### **PLANNING BOARD**

From: Brookline Planning Board

Subject: **Demolish existing two-family and construct a new one-family attached dwelling (two units)**

Location: 794-796 Heath Street

2 Open Space Diagram  
Scale: 3/16" = 1'-0"

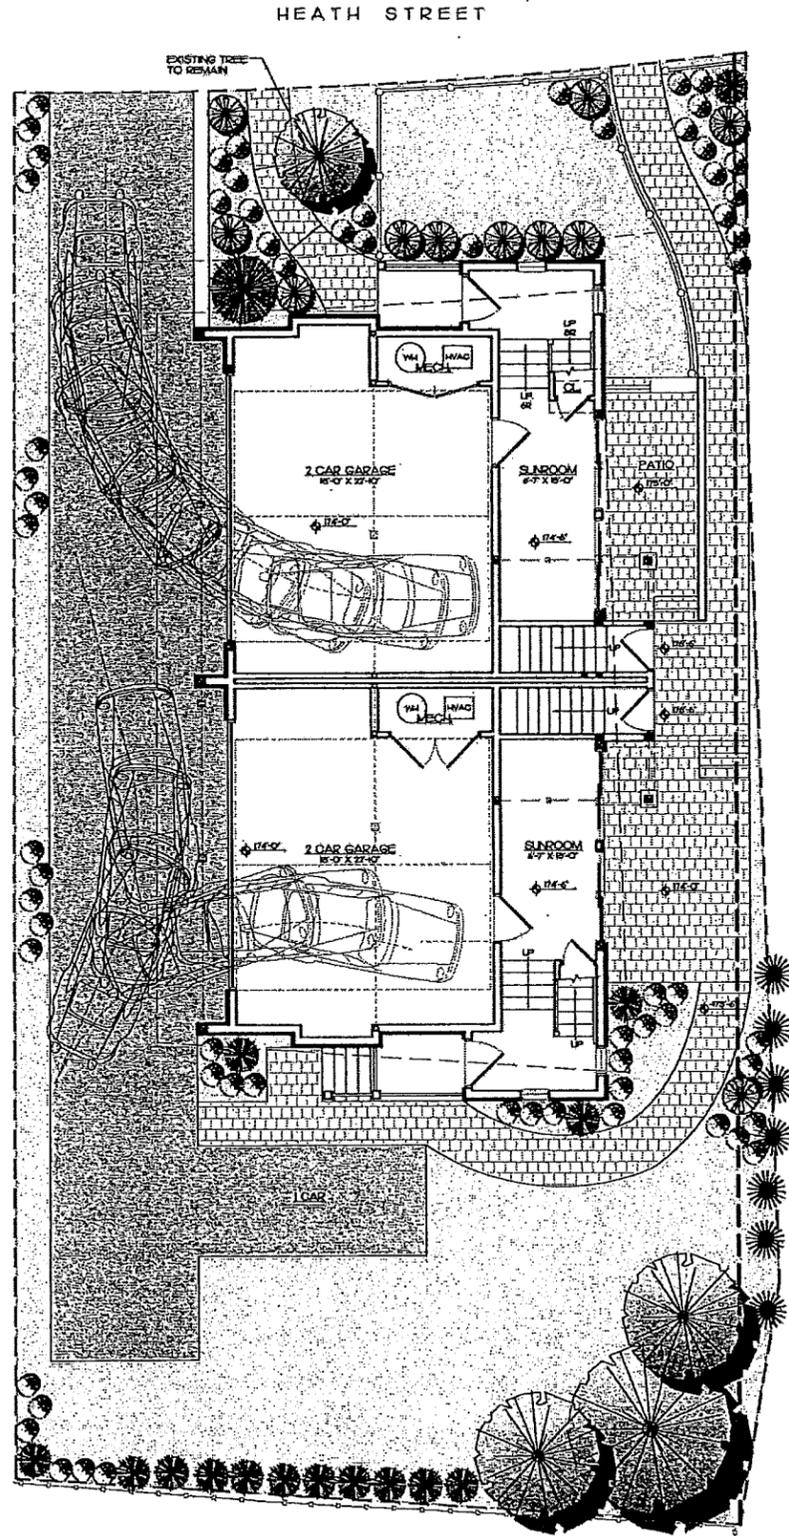
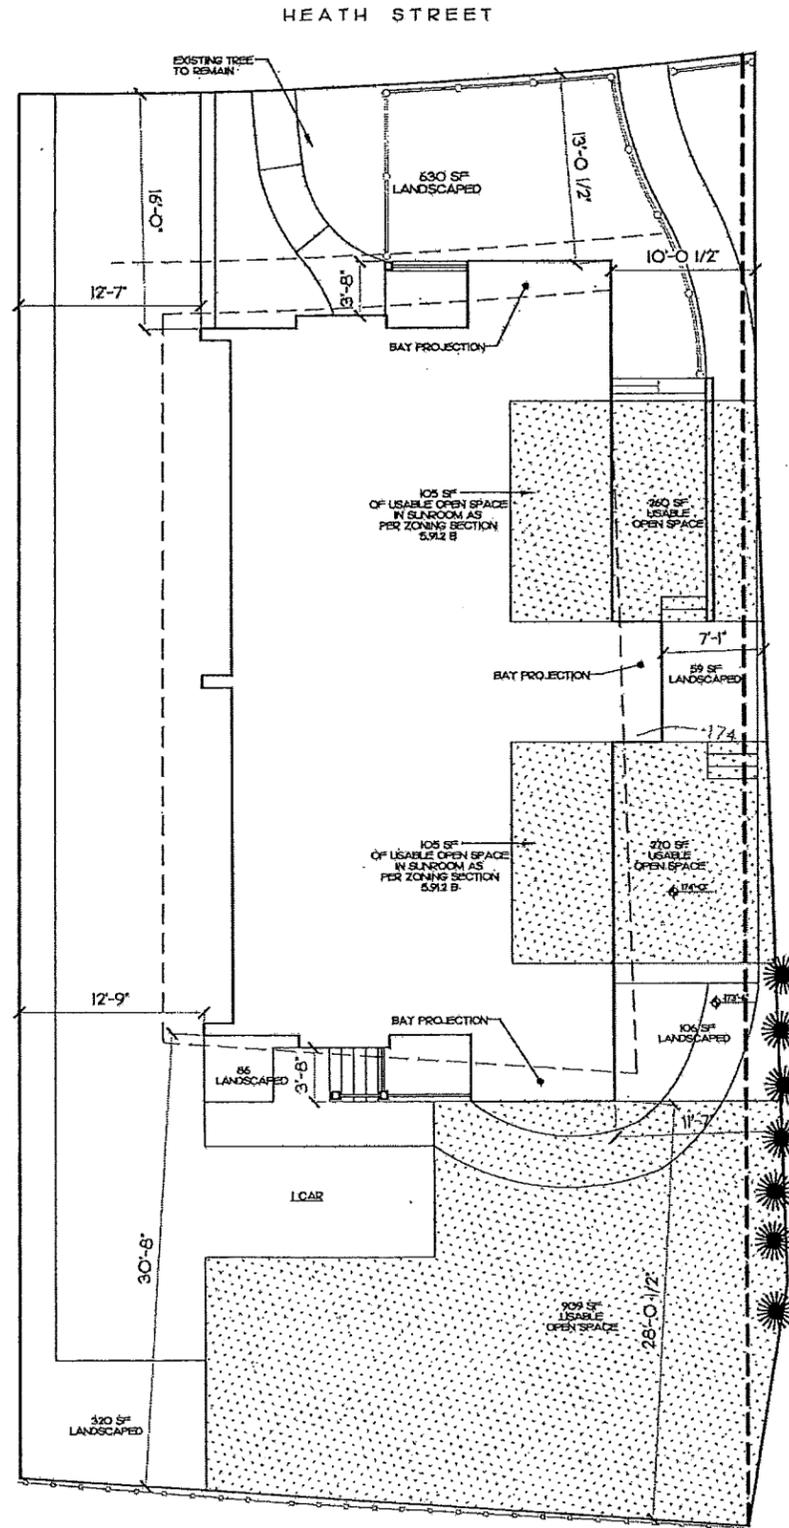
**Usable Open Space:** At total of 210 sf, the areas of the lower level sunrooms are counted toward usable open space. Without them, the project would not meet the minimum requirement for usable open space. Initially, the Chief Building Inspector did not have clear plans of the sunrooms and therefore cited Sec. 5.91, Minimum Usable Open Space. The Building Commissioner has confirmed this calculation .

The Planning Board might wish to review renderings that provide better views of left façade to confirm that 40 percent of the intervening wall area is constructed of transparent material that can be opened in good weather, pursuant to 5.91(2)(b).

- 1. Prior to the issuance of a Building Permit, the applicant shall submit to the Assistant Director for Regulatory Planning for review and approval (a) site plan with dimension labels, stamped and signed by a registered land surveyor, including setbacks, open space, parking area layout, fencing; and (b) floor plans and elevations. The applicant shall also include; (c) an illustration of the auto-turn radius on the driveway.**

1 Front Elevation  
Scale: 3/16" = 1'-0"

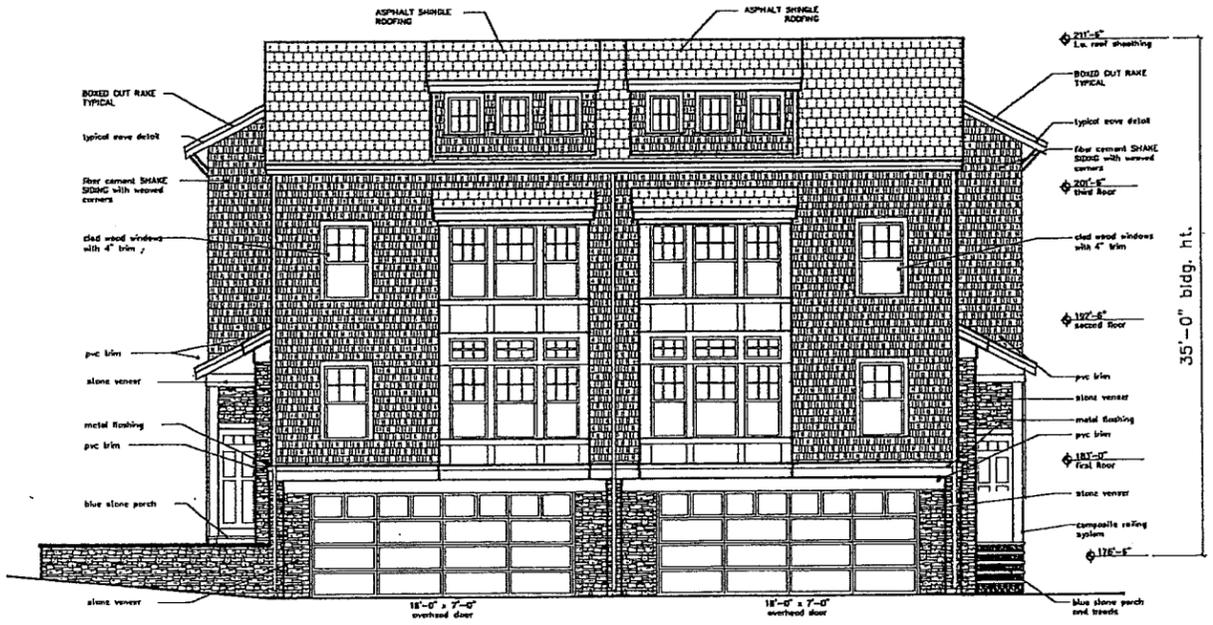
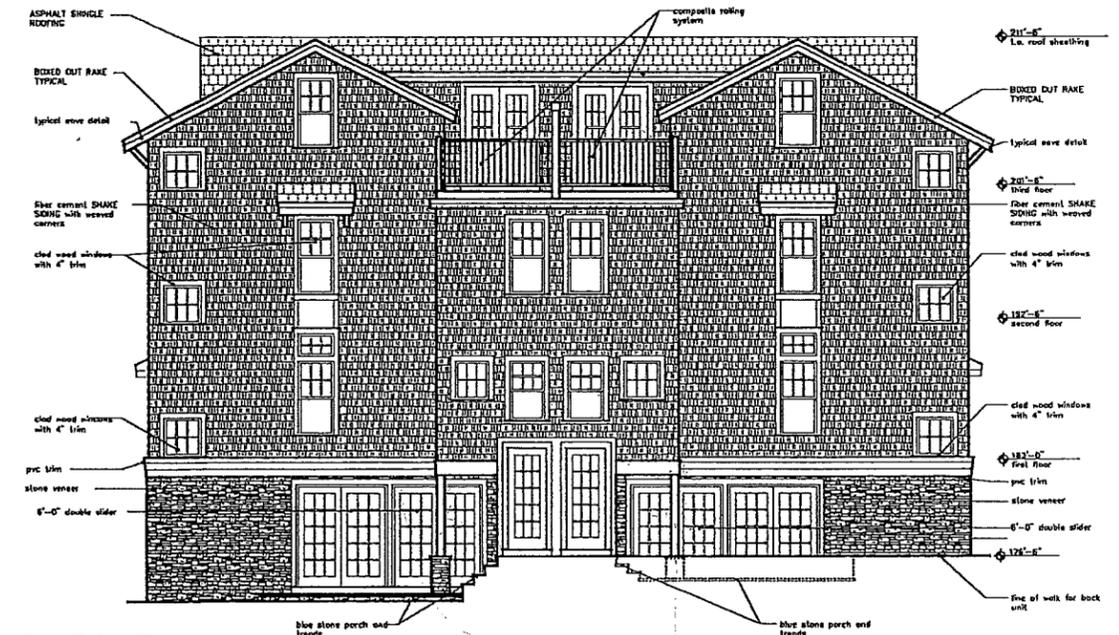
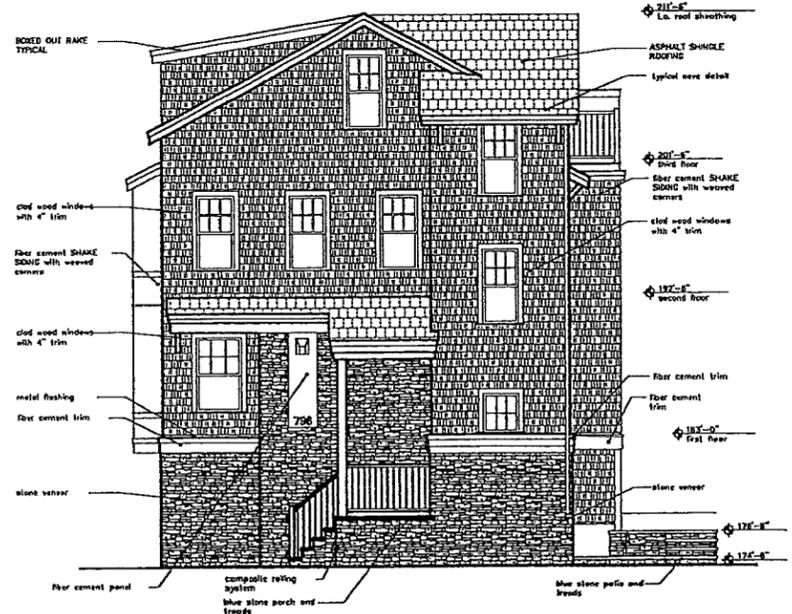
**Height and Massing:** The height was measured from grade indicated the front of the house on the elevations (176'-0") for a height of 35 feet. Topographic plans were submitted in a previous iteration of this proposal; however, they were not stamped by a registered land surveyor. The applicant selected a methodology for calculating height pursuant to Sec. 5.30(1)(a), which the Building Commissioner reviewed and approved when the proposal was first submitted. (The applicant has used a different methodology when he first submitted his proposal, which resulted in a citation for excessive height.)

It should be noted that at the 3-1/2-stories, the structure would be larger than comparable two-families on similarly undersized lots in the neighborhood. Although the two units are configured such that one entrance is in the front and the other in rear, the left and right facades read as four stories, more typical of a multifamily. The fenestration for each unit is a mirror image of the other on both facades, which contributes to this quality. The paving in the side setbacks does not accommodate landscaping that could screen these views.
